Addendum No.: 6

Date Of Addendum: February 14, 2017

PHASE 1B ENHANCEMENTS  
SILVER SANDS STATE PARK  
MILFORD, CT  
BI – T – 604

SK-1

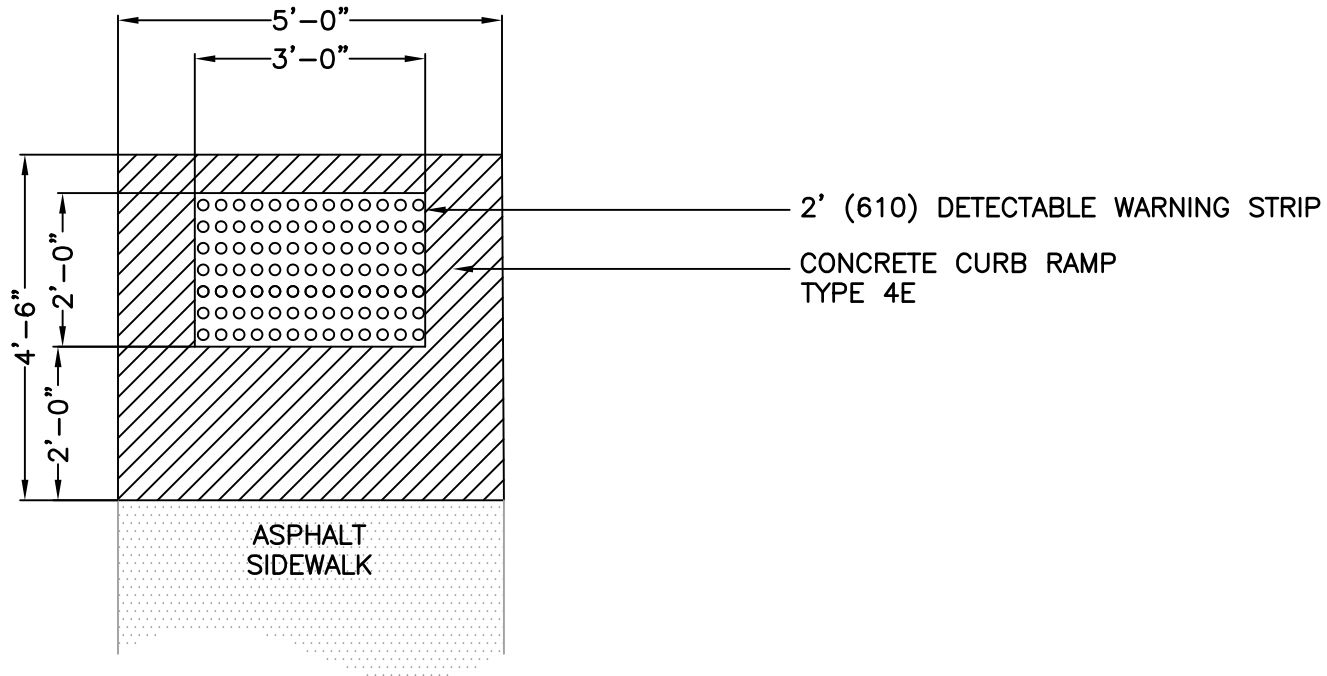
**QUESTION:** 21. The drawings show detectable warning strips in multiple locations throughout the park. Please provide a detail for installing the detectable warning strips in the bituminous concrete sidewalks?

**RESPONSE:** Ramps with detectable warning strips will need to be concrete. See SK-1.

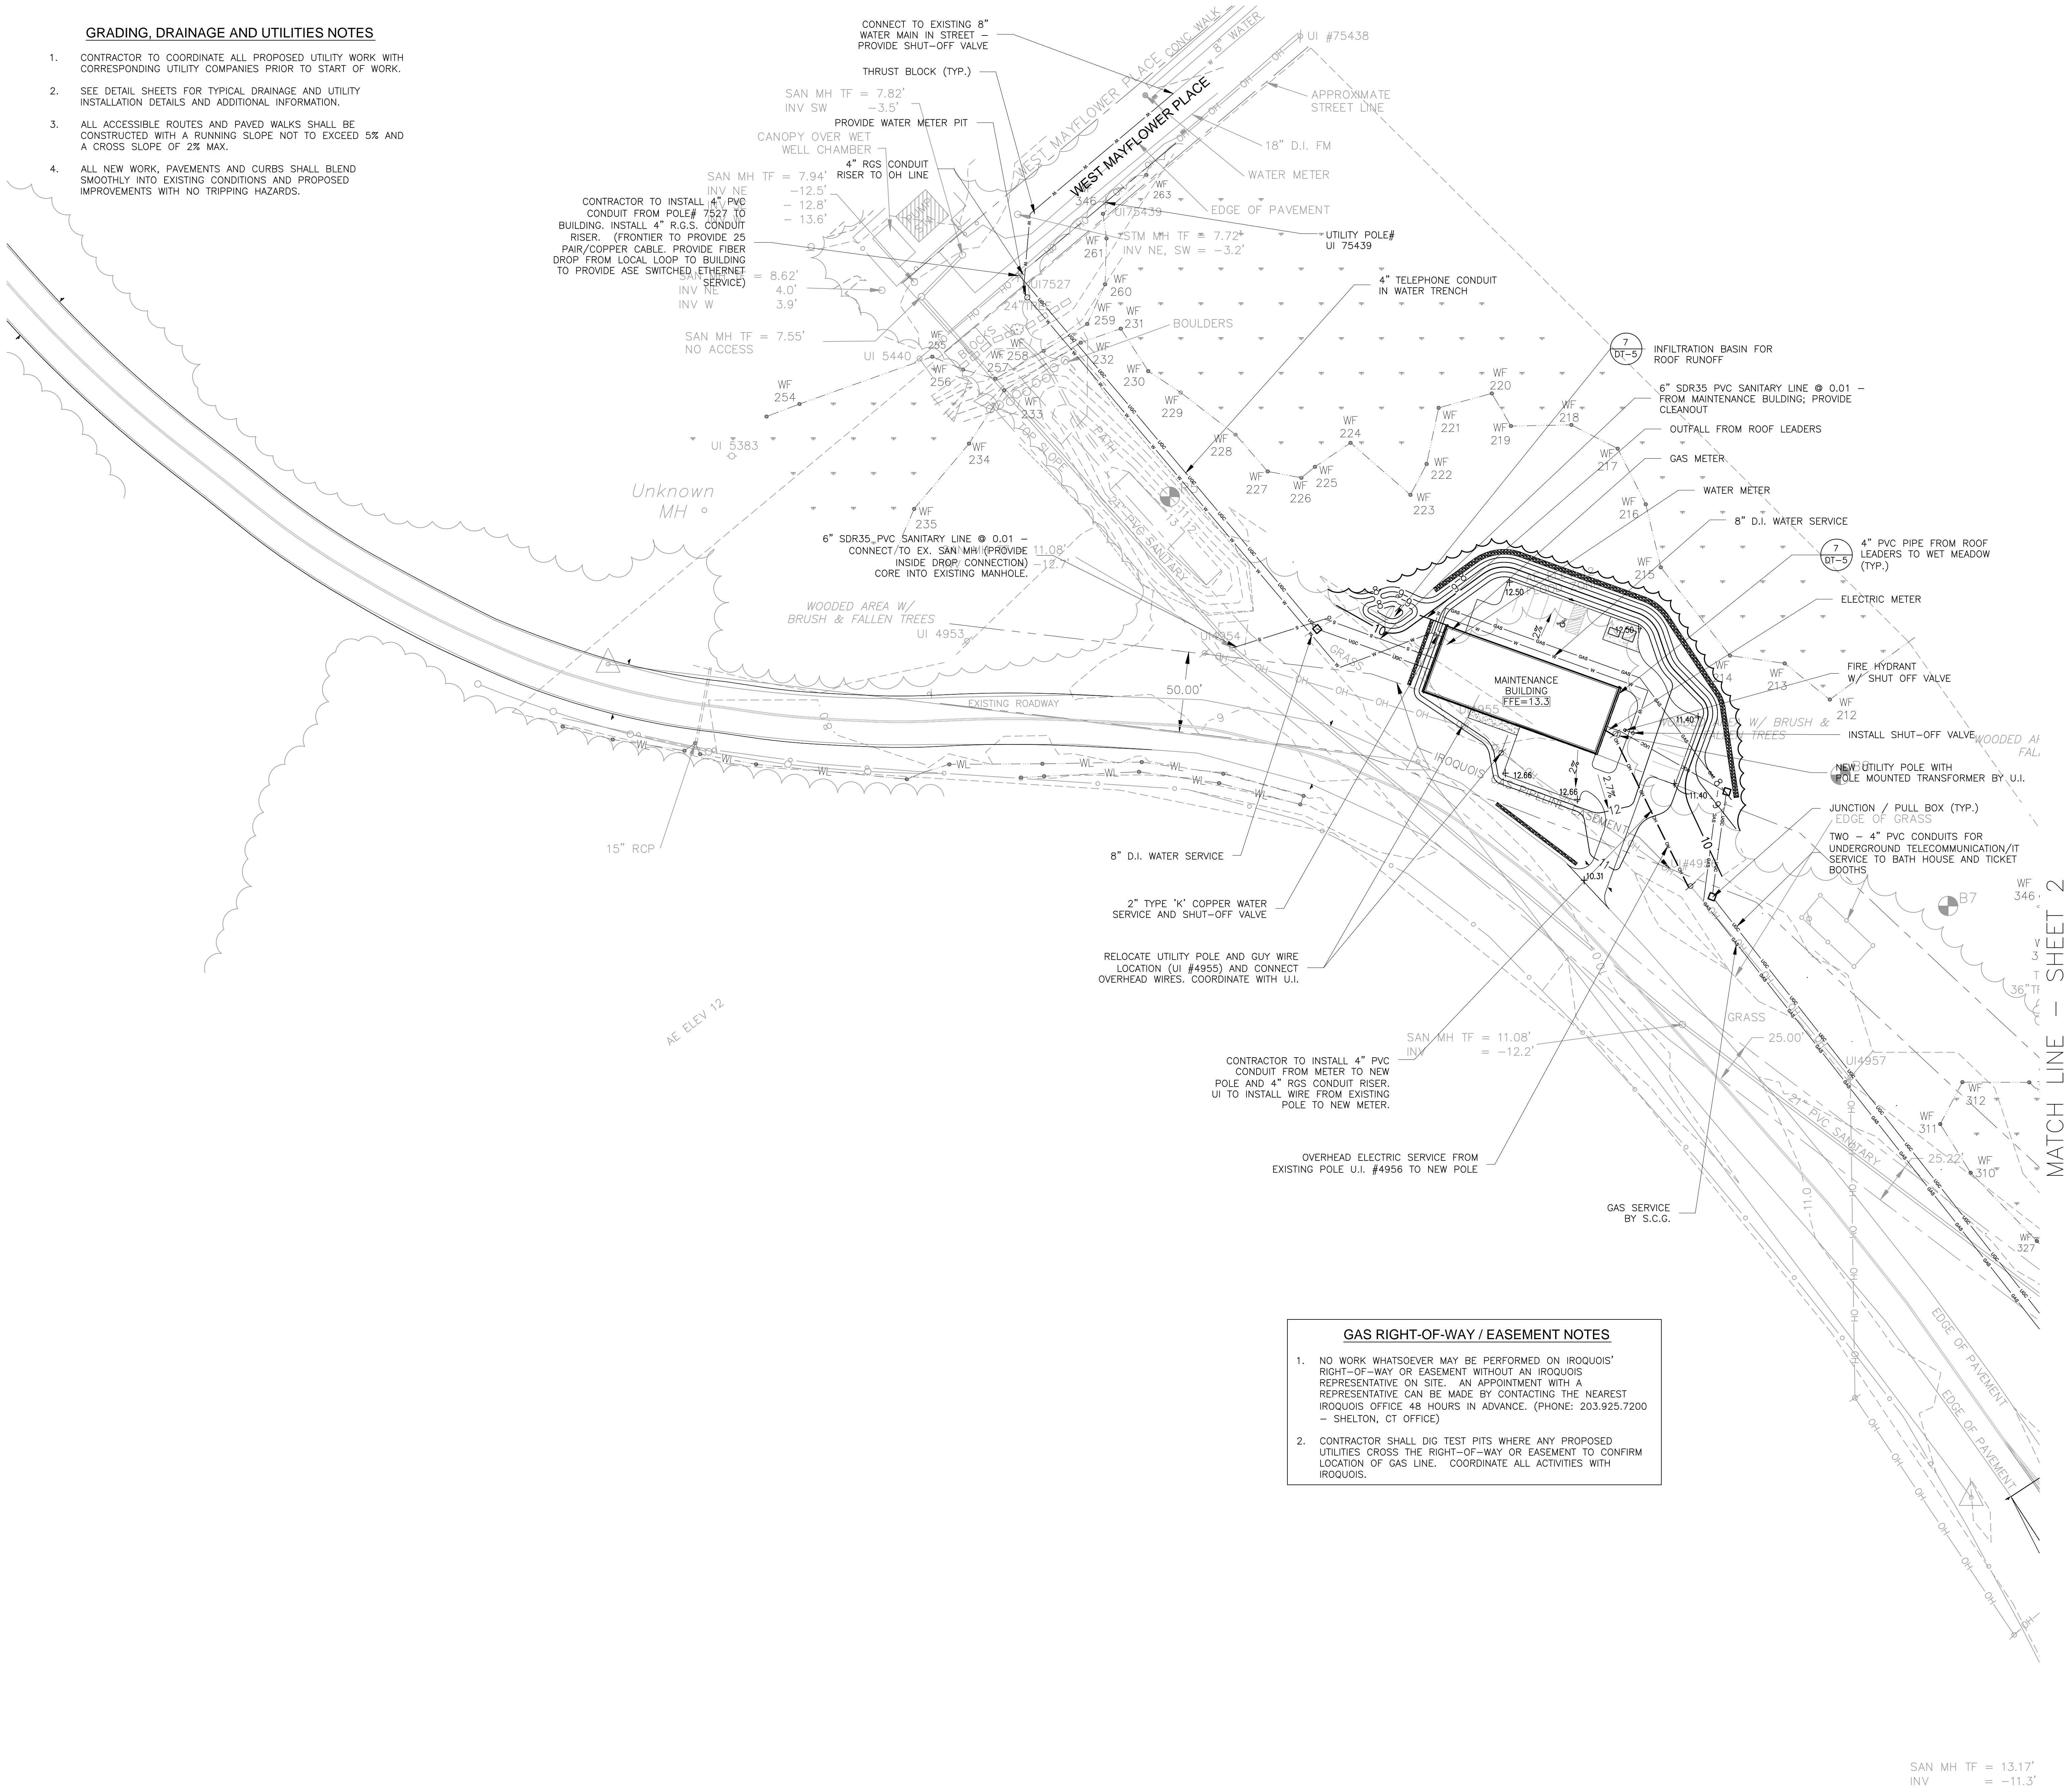
**QUESTION:** Refer to Grading Plans 1 thru 5, none of these drawings have the existing contours "labeled".

**QUESTION:** Refer to the following plans EC-1 Site Preparation Plan, G-1 Grading, Drainage & Utility Plan, LY-1 Site Layout Plan and C-1 Site Materials Plan, in all cases the westerly portion of the existing roadway does not show limits of construction for the proposed pavement edge roadway but just show an "incomplete" drawing at this point. Since new work is to take place here please furnish proper drawing(s) showing the actual construction limits here.

**QUESTION: 12.** On drawing G-1 it shows a new gas service by S.C.G. Will the utility company or the contractor be responsible for trenching and backfill for the gas service pipe? Also who will be responsible for any fees associated with S.C.G.?

**QUESTION: 14.** On drawing G-1 there is a note that says connect to existing 8" water main in street, provide shut off valve. Who is responsible for the fees associated with tying into the water main in the street?

Existing grades elevations have been turned on. Replace drawings G-1 thru G-5.

**RESPONSE:** The contractor will be responsible for trenching and backfill. Service connection fees will be the State's responsibility.

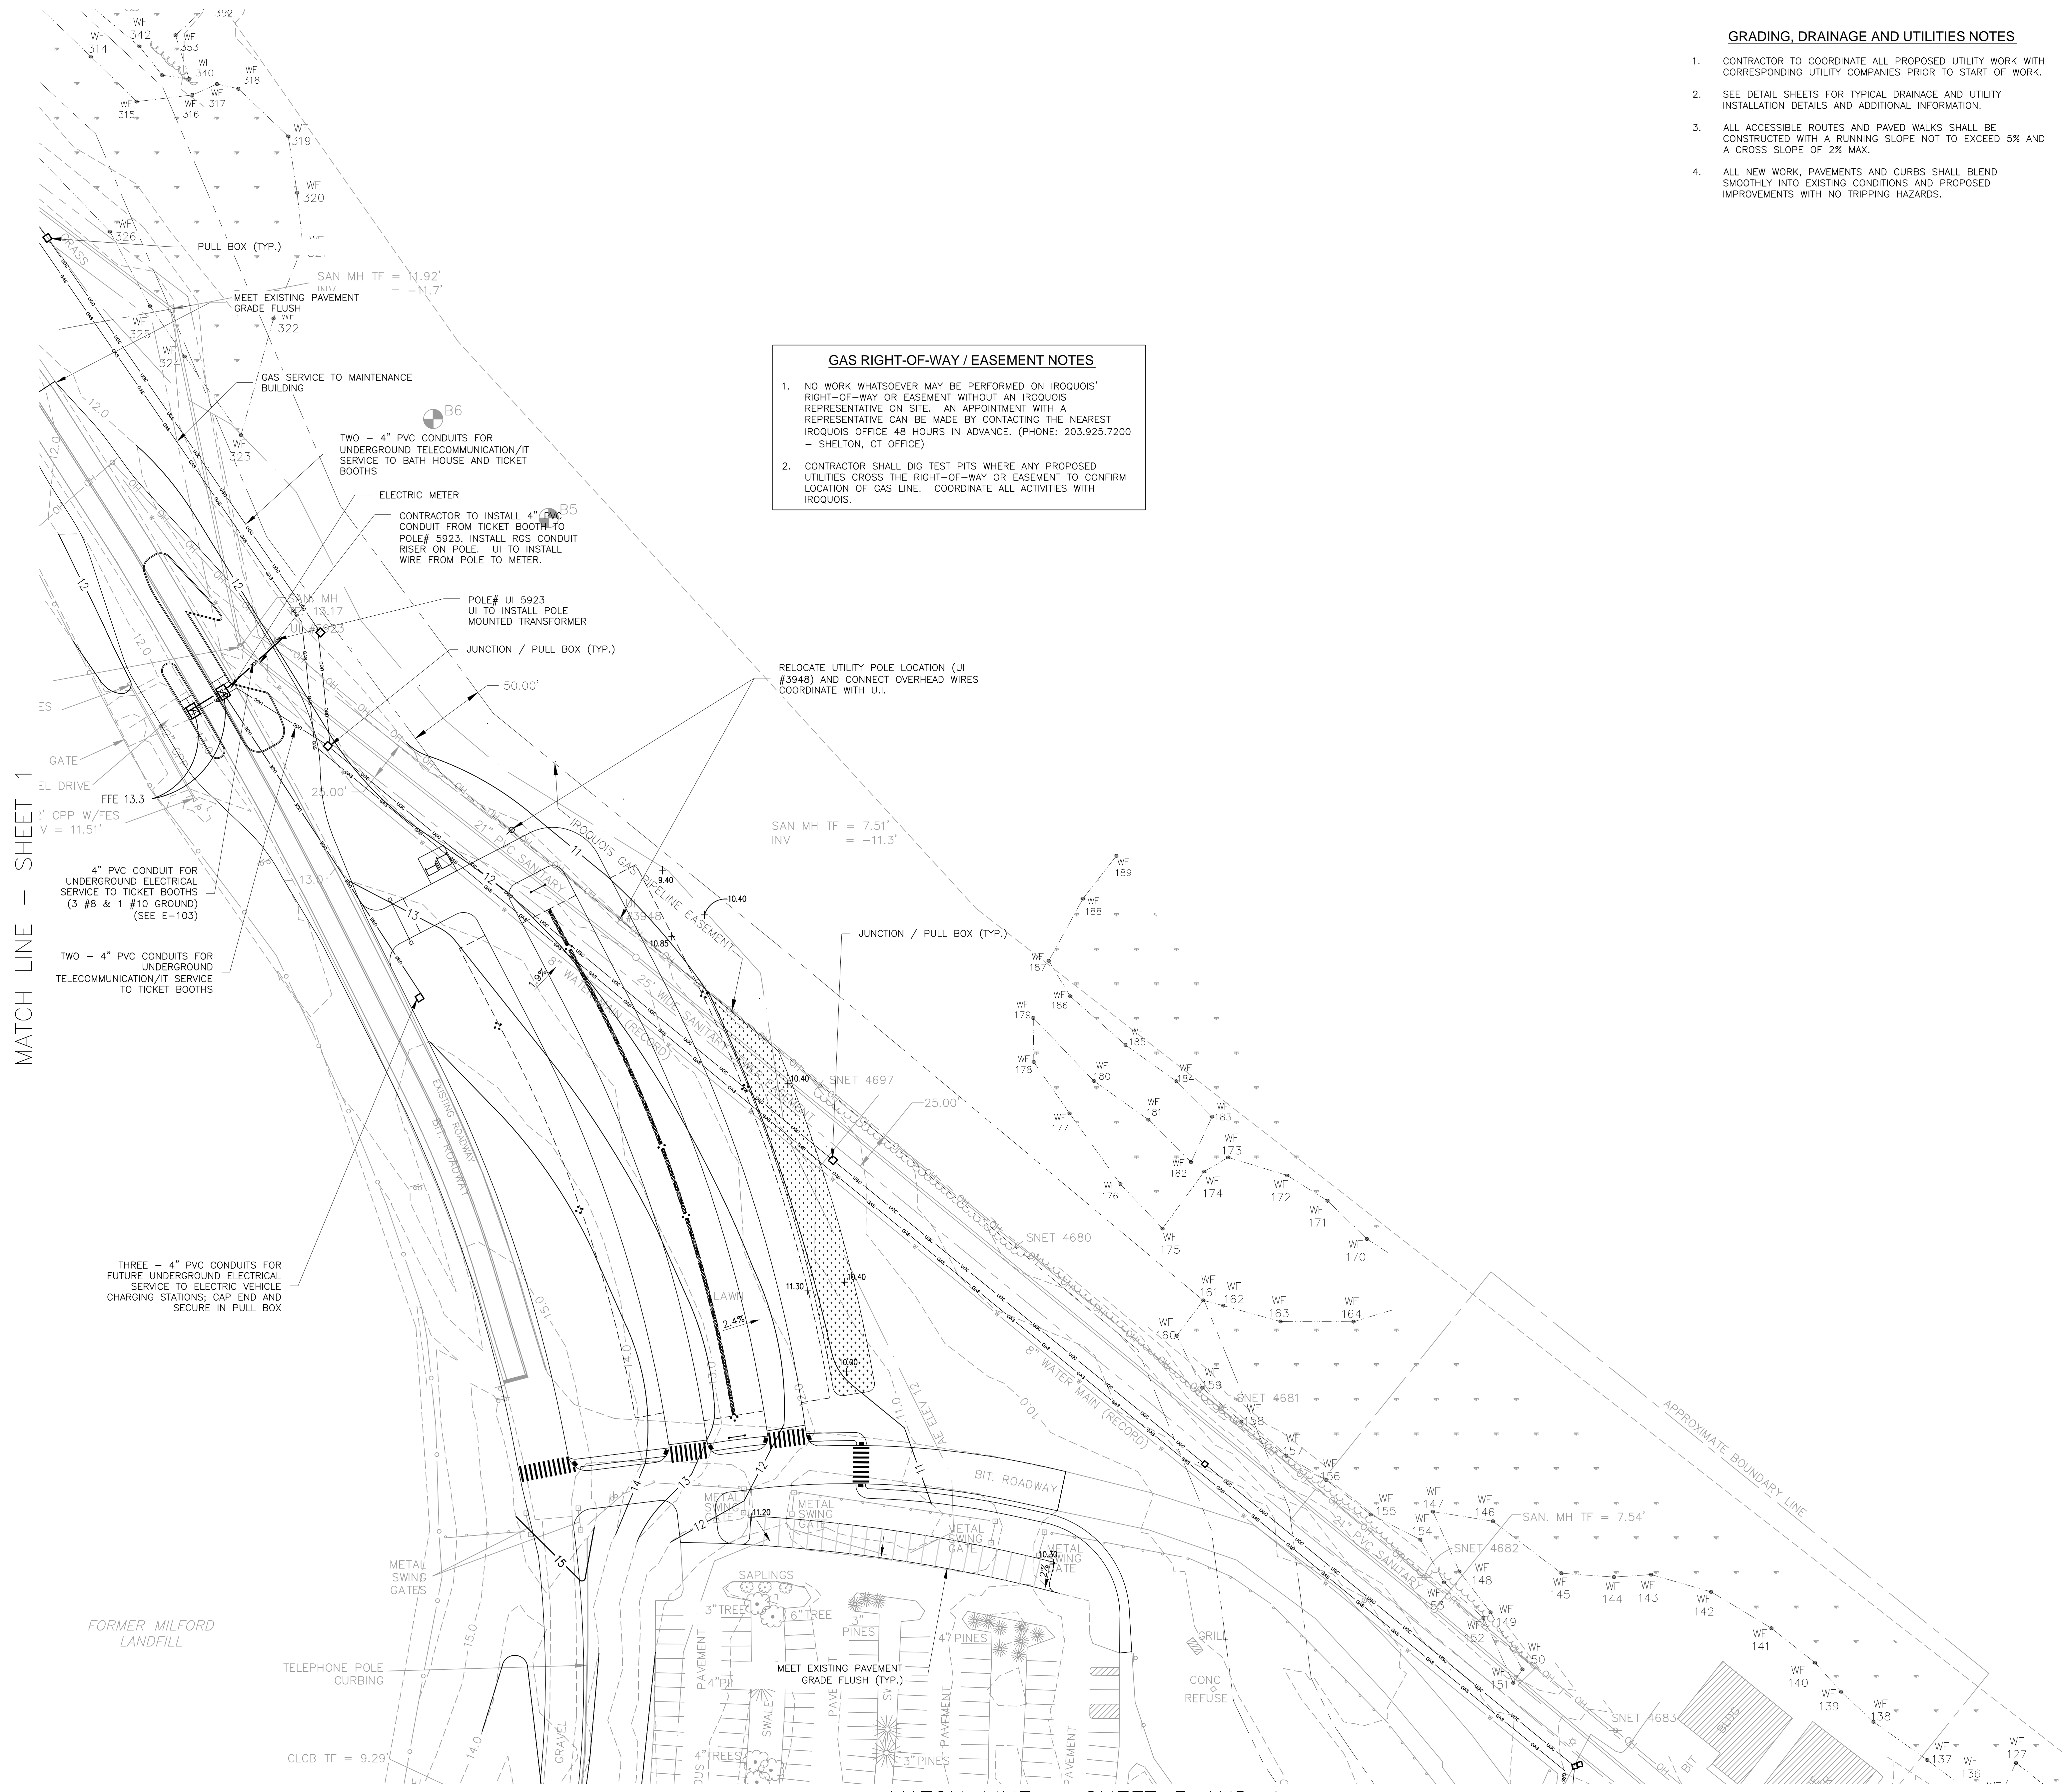
4. Refer to G-2 "Grading, Drainage & Utility Plan" and LY-2 "Layout Plan 2 of 7" note the existing Layout Plan states the existing Roadway is to be replaced and a new roadway is to be installed yet the Grading Plan(s) do not show

**QUESTION:** Refer to Drawings G-2 Grading, Drainage & Utility Plan 2, EC-2 Site Preparation Plan 2 and C-2 Site Materials Plan 2. On Drawing G-2 the proposed Gas Line and UGC is shown but Drawings EC-2 and C-2 do not show work on any kind for the Gas Line & UGC running North Northwest to South Southeast please clarify.

**RESPONSE:** Drawing G-2 shows utility work, EC-2 is for erosion control and C-2 is for materials. G-2 shows the utilities correctly.
